Technical Bulletin	TB 10186

Product – Part affected:
Repeat panel, retro fit kit. VSRPT-MRC

Illustration of 16 line display door.

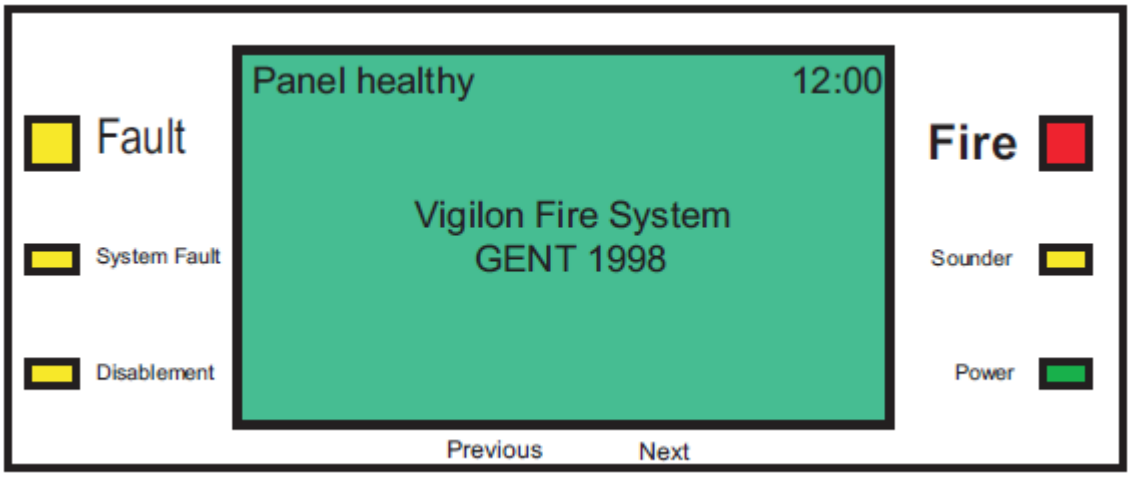
Details:
An issue has been found with the repeat panel retro fit kit, when used with old vigilon repeat panel doors; 16 line displays only.
Marked as option 3 in the instructions.

When the retro kit is fitted to these doors the buzzer is permanently on. All other functions of the repeat panel work as normal.

Action:
This issue has been rectified on any retro fit kits manufactured after 7/5/13.
UPDATE: Fix was incorrectly implemented, only those with dates after 15/8/13 have the correct fix.

If you have any site that suffers from this issue please express exchange the retro fit kit (VSRPT-MRC) referencing this Technical Bulletin.
